Agenda Report

SUBJECT: CALL FOR REVIEW OF DESIGN COMMISSION DECISION TO APPROVE A NEGATIVE DECLARATION AND CONCEPT DESIGN REVIEW FOR A NEW MIXED-USE BUILDING AT 260 SOUTH ARROYO PARKWAY

TO: Design Commission
FROM: Richard J. Bruckner, Director, Planning & Development Department
SUBJECT: Application to Adopt an Initial Study, Negative Declaration, and Concept Design Approval
260 South Arroyo Parkway (Milan Lofts)
Case #PLN 2004-00297
Council District 6

Cordova Street
 Elevation

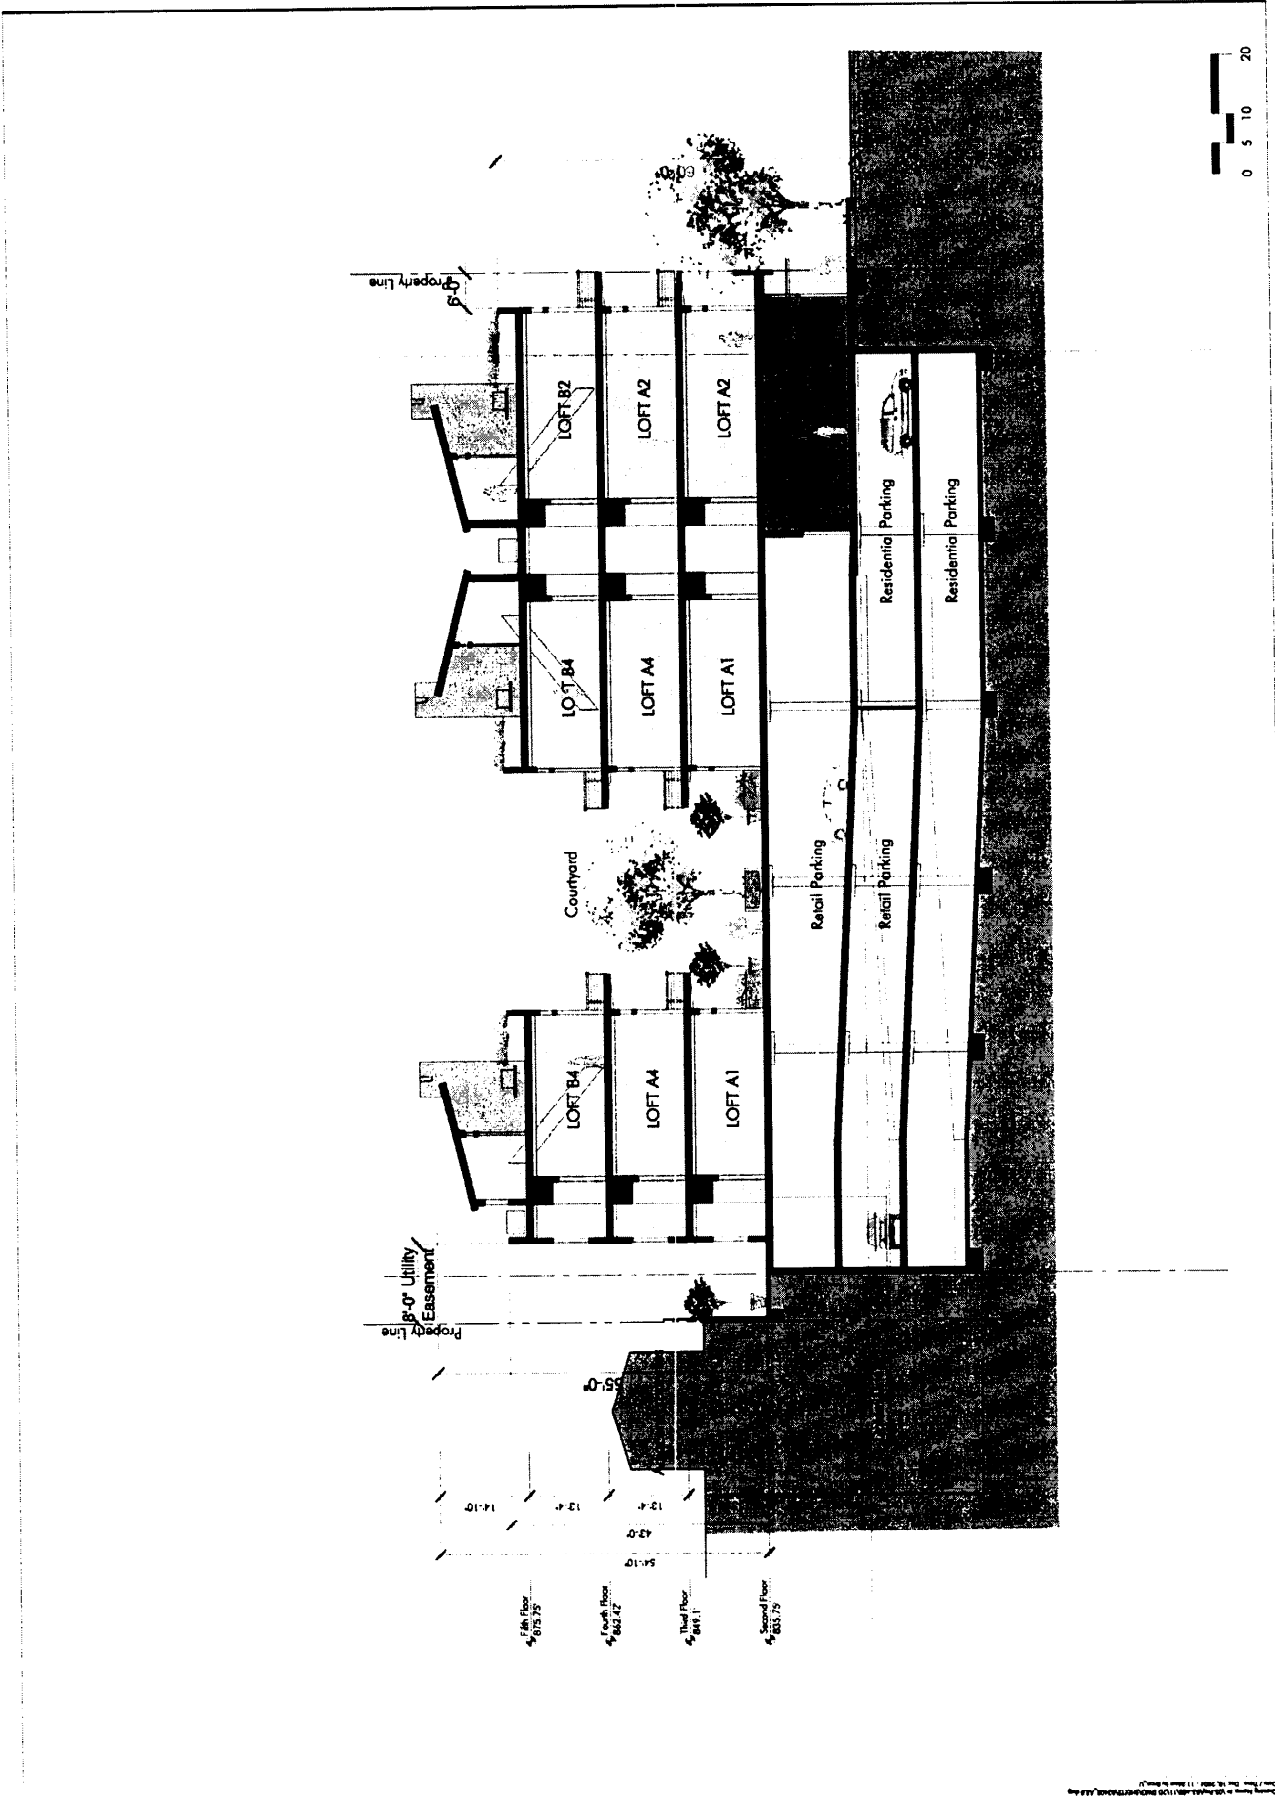
- b) Restudy the curvature at the retail corner.
 - c) Add more solidity to the retail base to support the vertical walls above it.
 - d) To avoid the appearance of thin walls and surface-applied detail, recess the windows and patio doors approximately three inches behind the primary building wall. Recessing the window plane back from the building surface will enhance the level of detail of the building and create more solidity to the wall surfaces. *Source: Citywide Design Guidelines for Windows in Multi-family Residential Projects. Buildings should not have window frames flush with the stucco surface.*

- k) Among the issues to be carefully evaluated during final design are:
- location of retail signs
 - the detailing of the window assemblies and the location of operable and fixed window openings
 - balcony guardrail detail
 - detailing of raised planters
 - the screening of mechanical equipment, backflow preventor/utility vault/gas meters, dryer vents, and location of mechanical ventilation for parking garage and restaurant component (if applicable)
 - dimension and placement of aluminum reveals (e.g., Fry Reglet) within plaster surfaced walls
